**CITY OF EVERETT
REQUEST FOR BIDS NO. 25-66
ADDENDUM NO. 3**

Project: #ENG-25-66

This **Addendum No. 3** is issued to amend the Request for Services for **Request for Bids for ENG-25-66 Woodland Playground Renovation**.

1 ELECTRICAL DISTRIBUTION RISER / ENCLOSURE DETAIL NTS

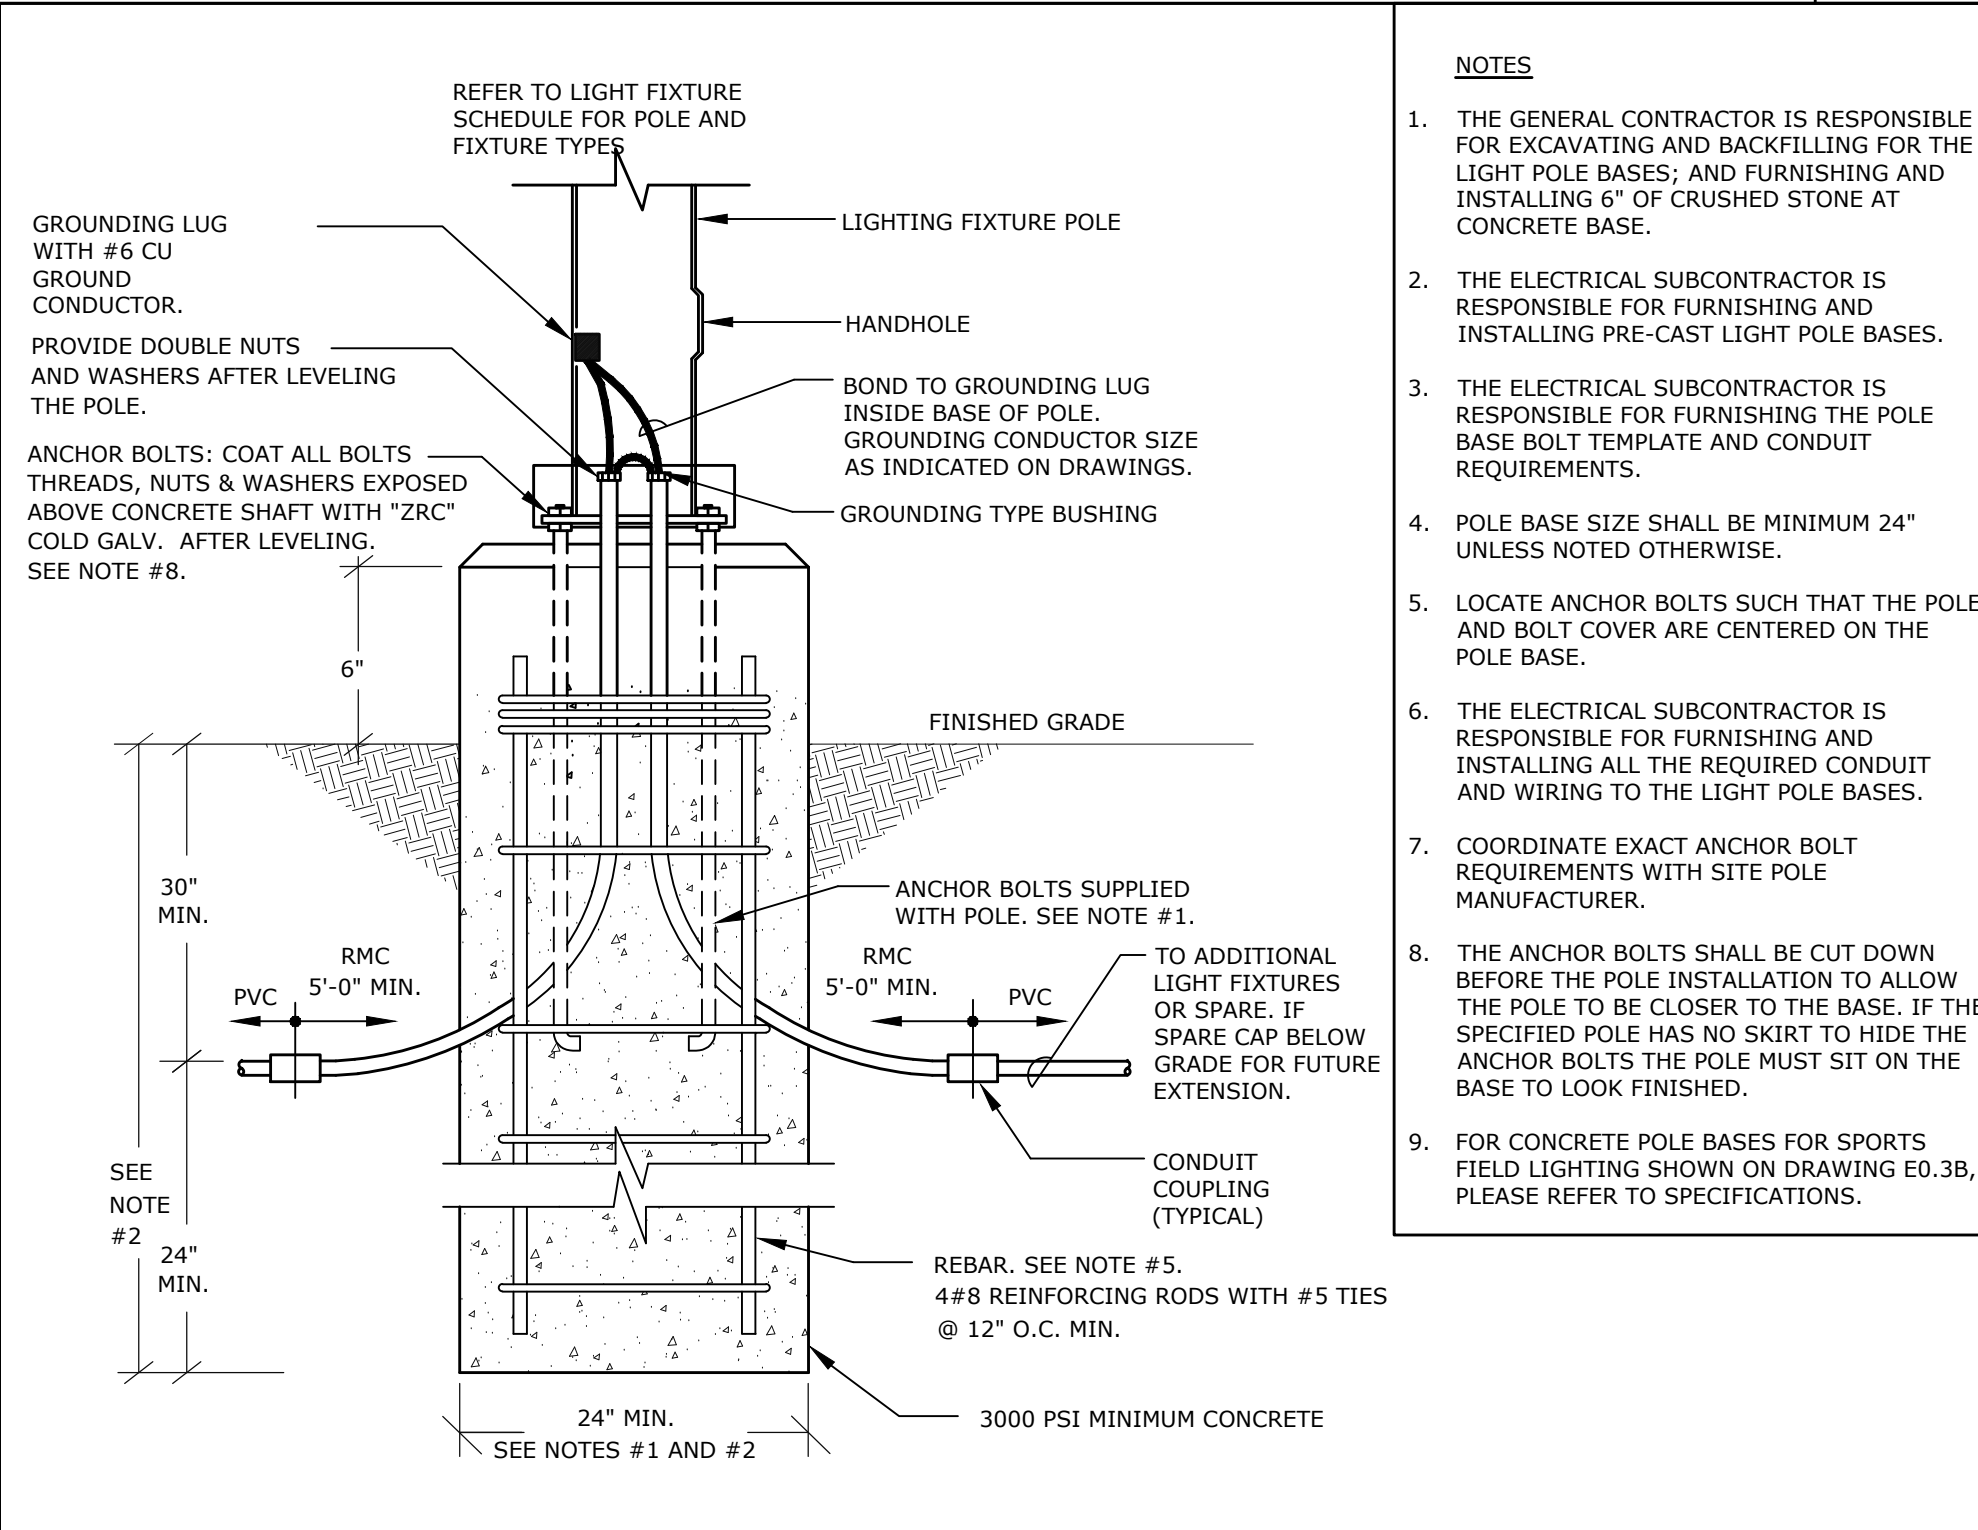
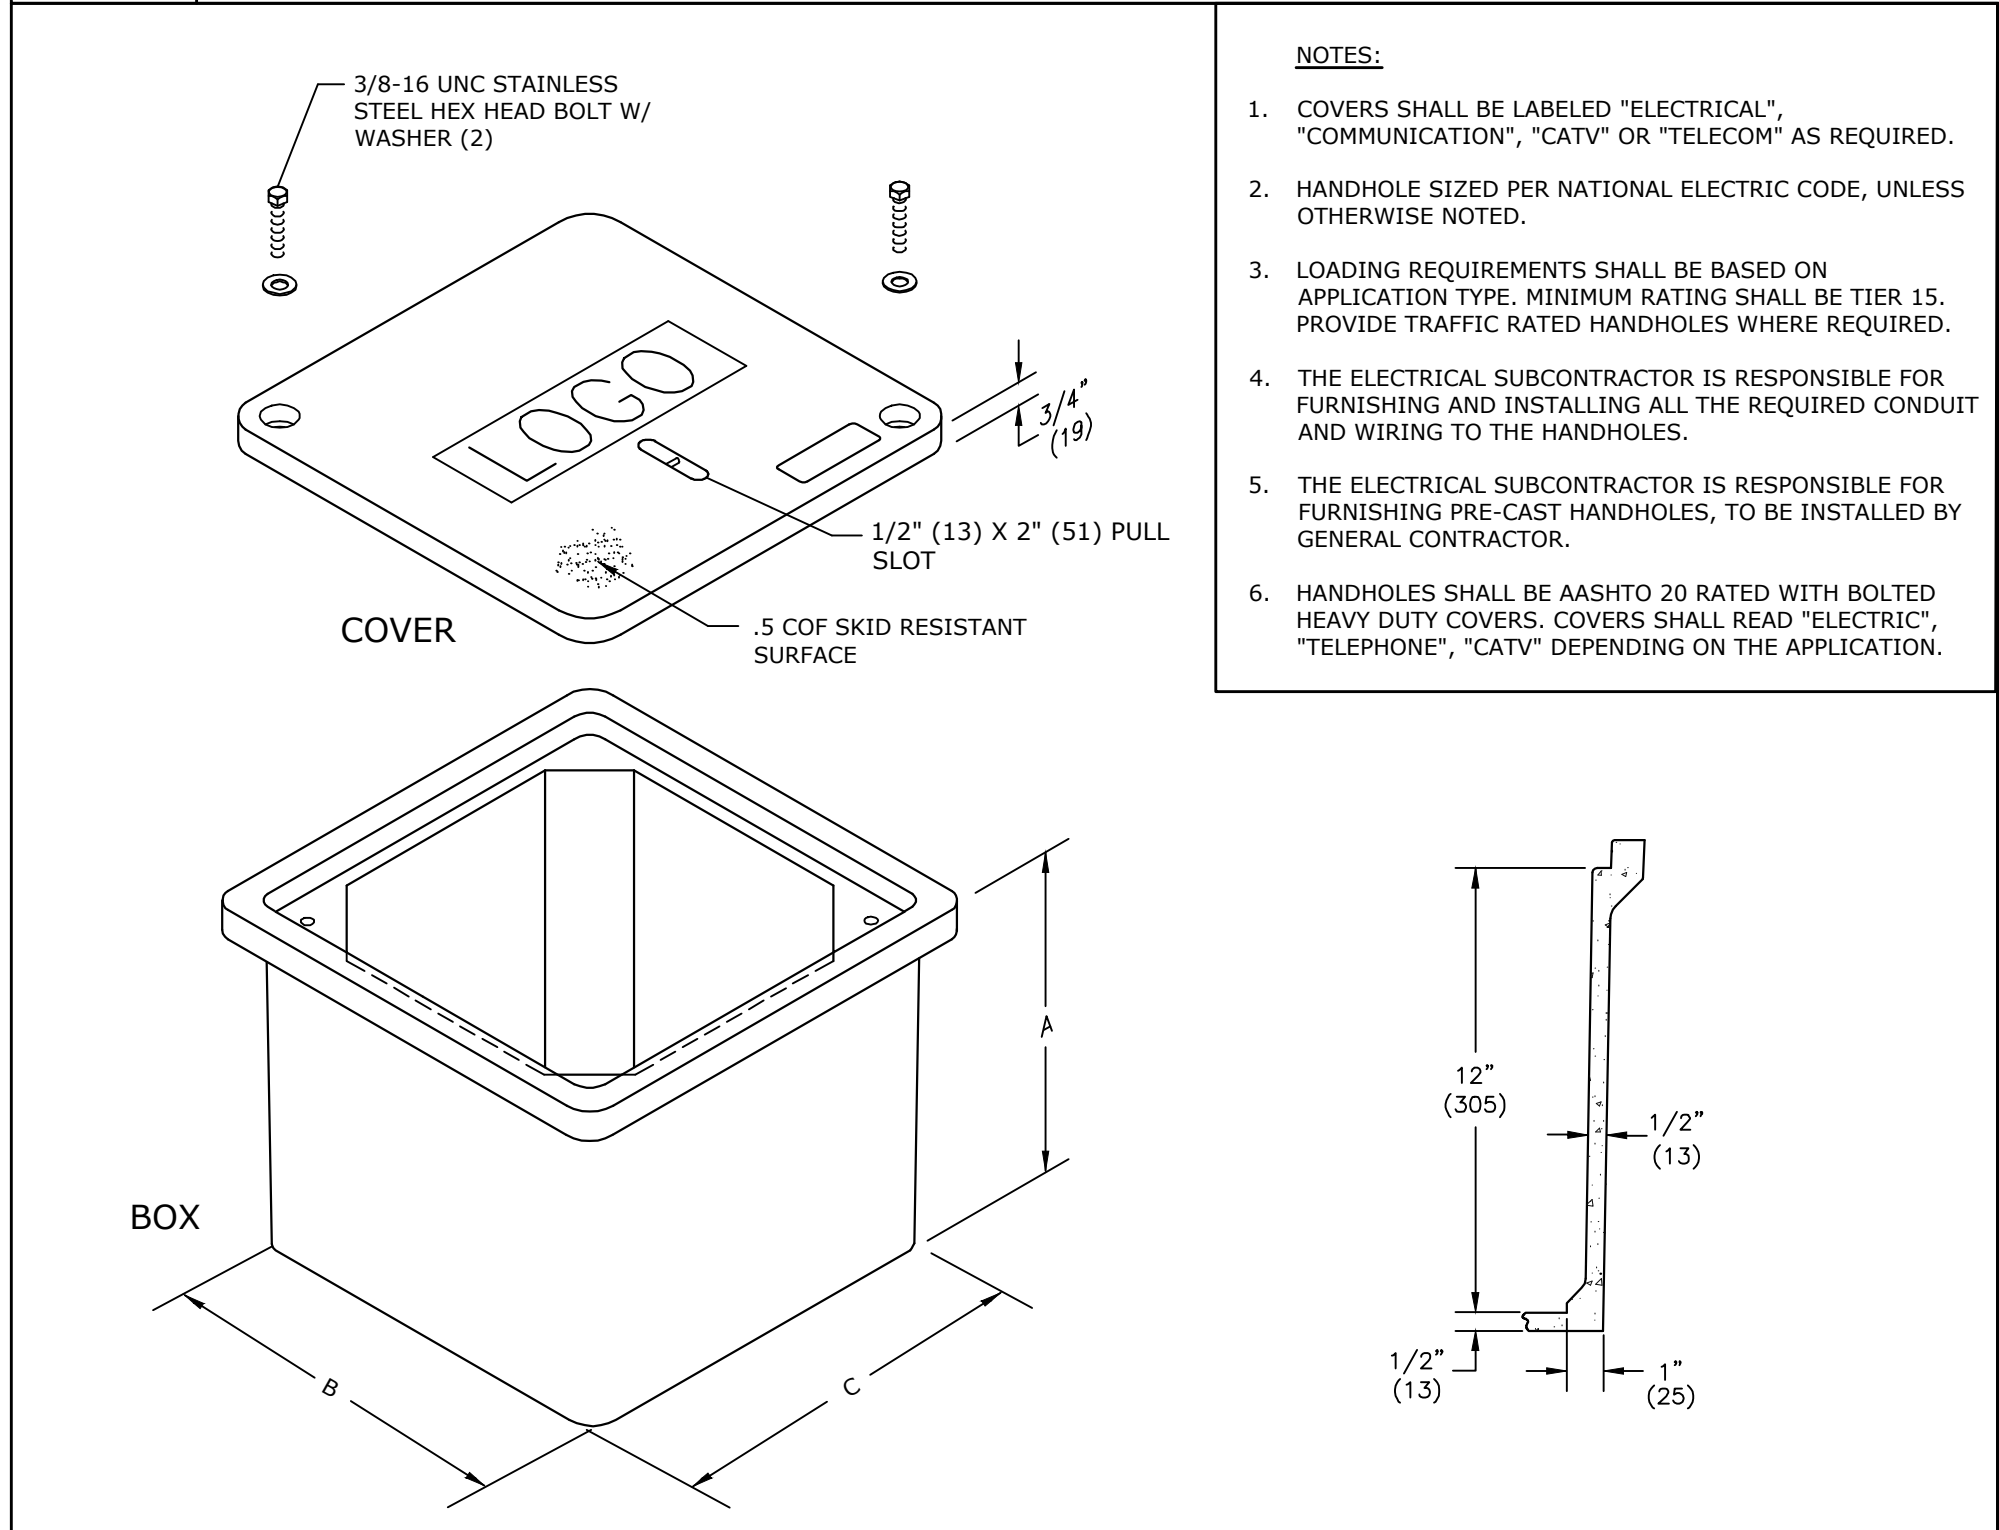
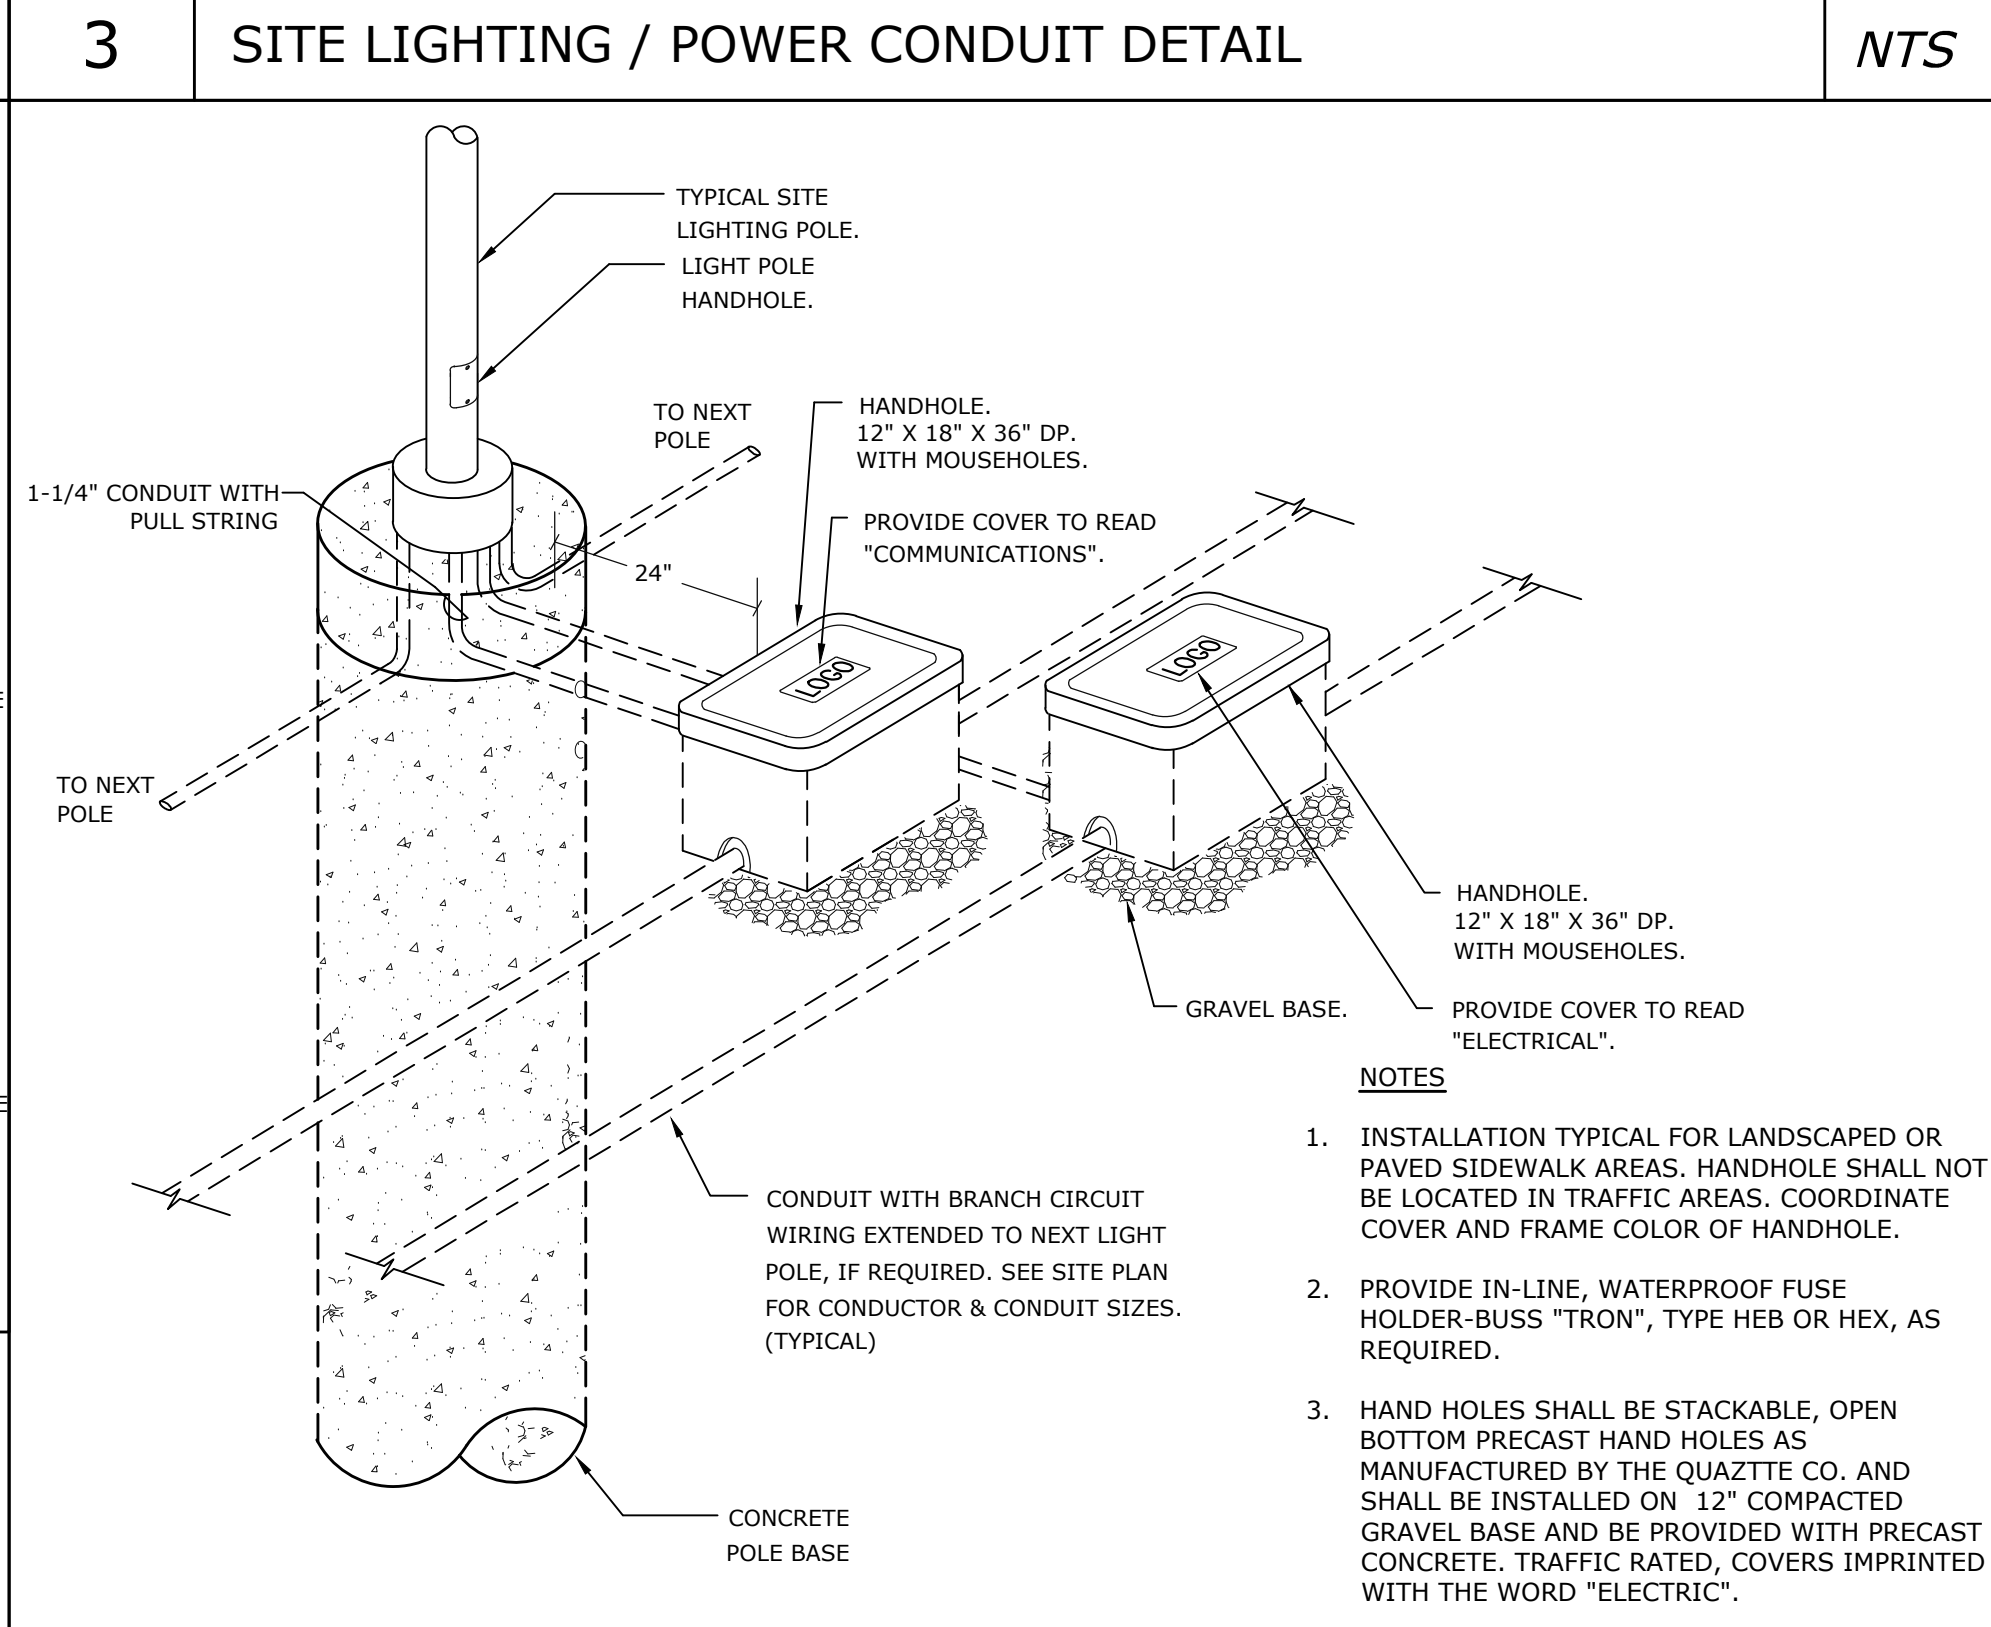
17. Are electrical permit fees for the project waived?
RESPONSE: Contractor is to pay all permit fees as required
18. Note 5 on drawing E1 calls for AASHTO 20 rated handholes. Handhole details on drawing E2 call for Quazite Tier 15 rated handholes. Please confirm that handhole are to have a Tier 15 rating as Quazite does not make AASHTO 20 rated handholes.
ART ELECTRICAL ENGINEER RESPONSE: Handholes are to be Quazite Tier 15 rated, consistent with the details shown on drawing E2. AASHTO H20 rating is not required unless the handholes are located within vehicular traffic areas.
If any handholes are installed in a roadway, driveway, or area subject to vehicle loading, the contractor shall provide traffic-rated (AASHTO H20) handholes suitable for that condition. Otherwise, Tier 15 is acceptable for all non-vehicular locations. Please coordinate field locations accordingly.
